APPLICATION NO.	FILING DATE	FIRST NAMED INVENTOR	ATTORNEY DOCKET NO.	CONFIRMATION NO.
10/684,684	10/15/2003	Kohci Yamanaka	Q76899	3402
23373 7590 08/02/2007 SUGHRUE MION, PLLC 2100 PENNSYLVANIA AVENUE, N.W. SUITE 800 WASHINGTON, DC 20037			EXAMINER GARCIA, ERNESTO	
			ART UNIT 3679	PAPER NUMBER
			MAIL DATE 08/02/2007	DELIVERY MODE PAPER

Office Action Summary

DETAILED ACTION

FIG. 6

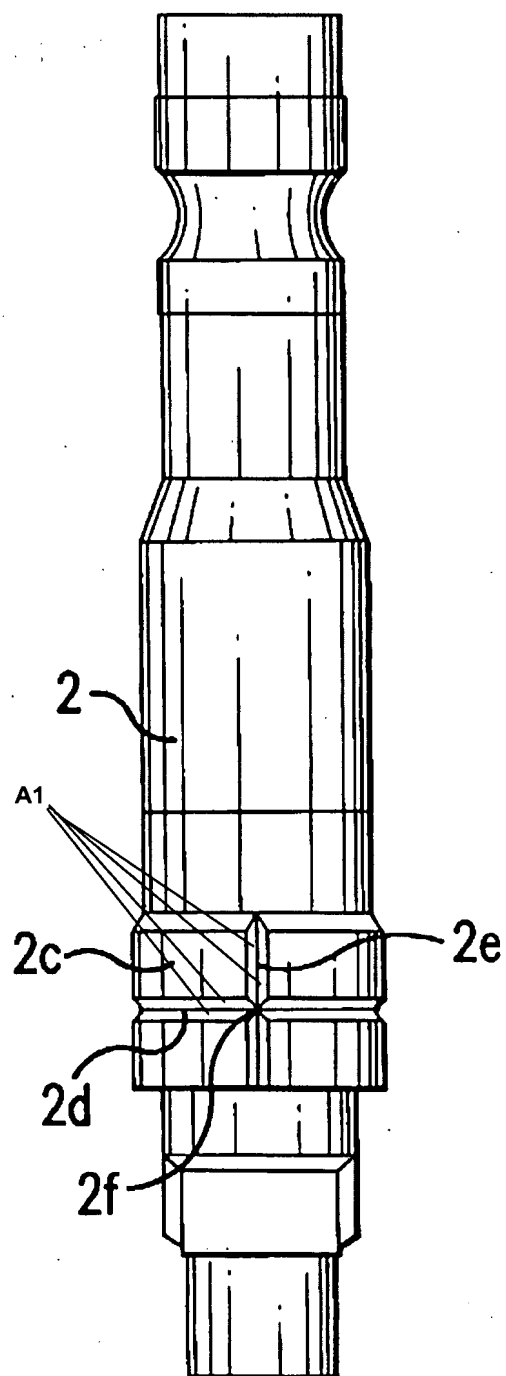
Attachment: one marked-up page of Yamanaka et al., 2003/0136604
